***Development Special Use Permit #2019-0021***  
***Special Use Permit #2019-0090***  
***Special Use Permit #2019-0091***  
***Modera Tempo Amendment***

Application	General Data	
<b>Project Name:</b> Modera Tempo (Amending DSUP #2011-0030)  <b>Location:</b> 650 South Van Dorn Street  <b>Applicant:</b> Mill Creek Residential Trust, LLC, represented by Ken Wire, Esq., WireGill	<b>PC Hearing:</b>	November 7, 2019
	<b>CC Hearing:</b>	November 16, 2019
	<b>If approved, DSUP expiration:</b>	November 16, 2022 (36 months)
	<b>Plan Acreage:</b>	6.31 Acres
	<b>Zone:</b>	CDD #17
	<b>Proposed Use:</b>	Residential & Commercial Retail
	<b>Dwelling Units:</b>	492
	<b>Gross Floor Area:</b>	549,890 sf (15,000 sf retail)
	<b>Small Area Plan:</b>	Landmark/Van Dorn
	<b>Green Building:</b>	Complying with the Green Building Policy

<b>Purpose of Application:</b>
The applicant requests an amendment to DSUP#2011-0030 to approve Development Special Use Permit #2019-0021, with modifications, to reallocate residential parking spaces in the garage for commercial/retail uses and associated Special Use Permits for a parking reduction to permit more than 30% compact commercial parking spaces (SUP #2019-0090)

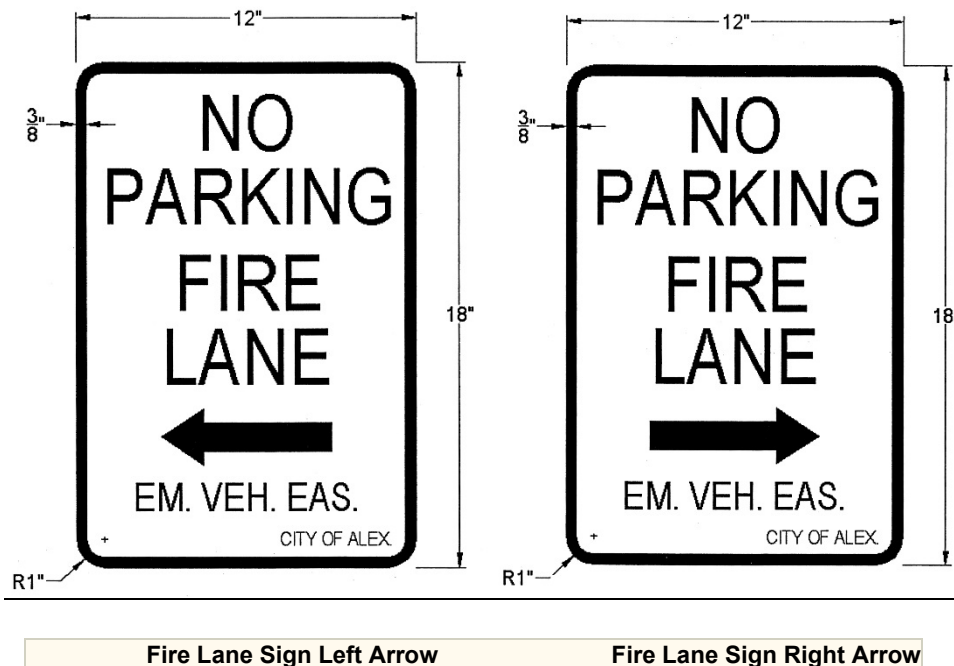
- C-7 The final site plans shall show placement of emergency vehicle easement signs. See sign detail and placement requirements below. Current plans do not have correct signage.

**Figure 1020.1.6.2 Example Building Footprint Sign**

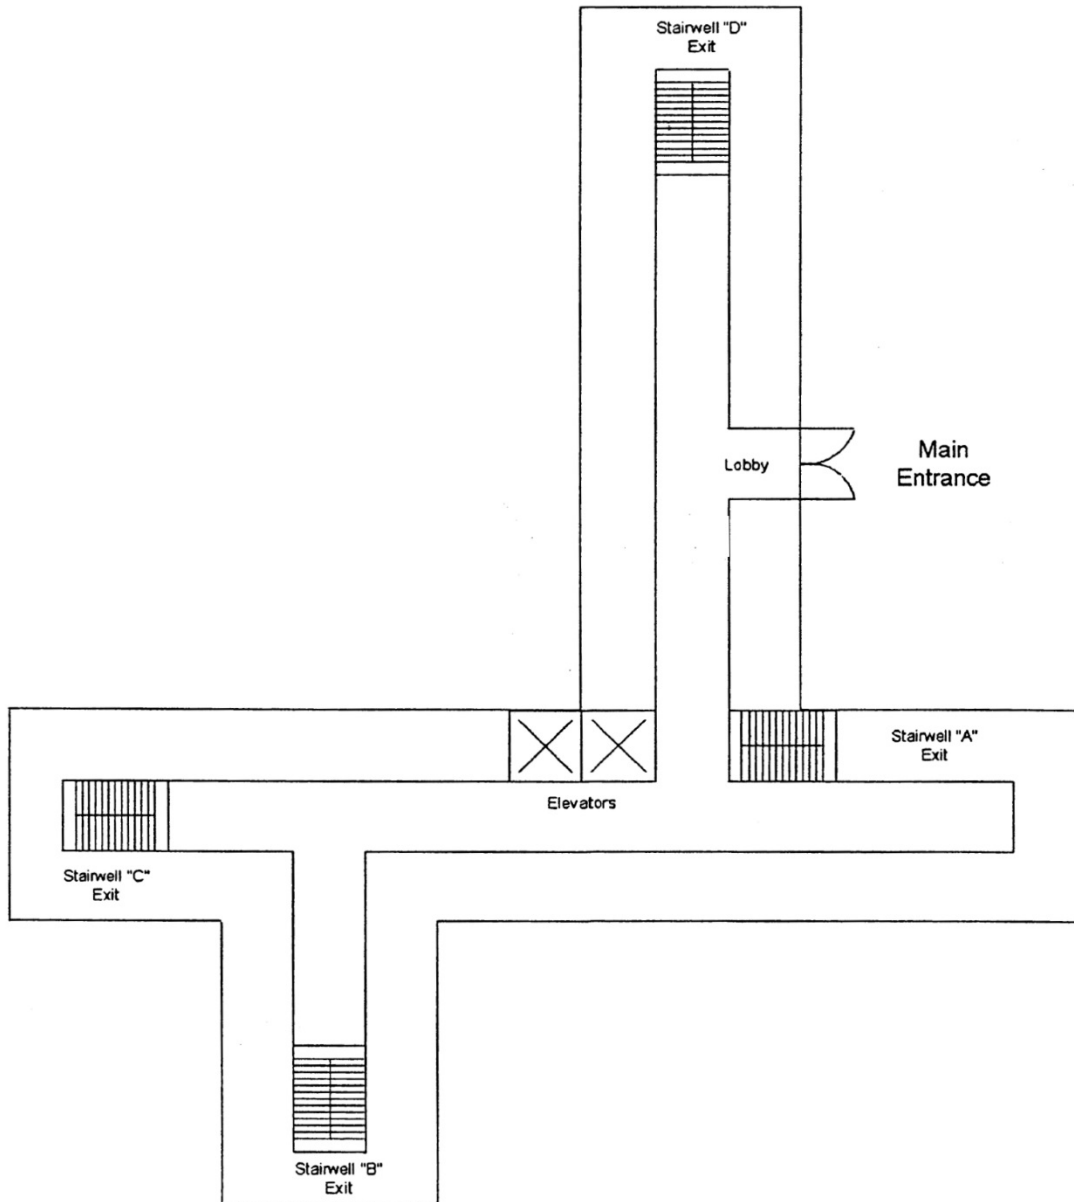
- C-9 Provide Stairway Identification. A sign shall be provided at each floor landing in interior vertical exit enclosures connecting more than three stories designating the floor level, the terminus of the top and bottom of the stair enclosure and the identification of the stair. The signage shall also state the story of, and the direction to the exit discharge and the availability of roof access from the stairway for the fire Department.

**Footprint requirements.** In buildings greater than three stories where there is no graphic representation of the building footprint, a simplified building schematic must be display in the lobby. The simplified building footprint shall be an overhead view of the buildings exterior and the general layout of the lobby of the first floor. Stairways shall be denoted by letter as stated in section 1020.1.6. (See Figure 1020.1.6.2)
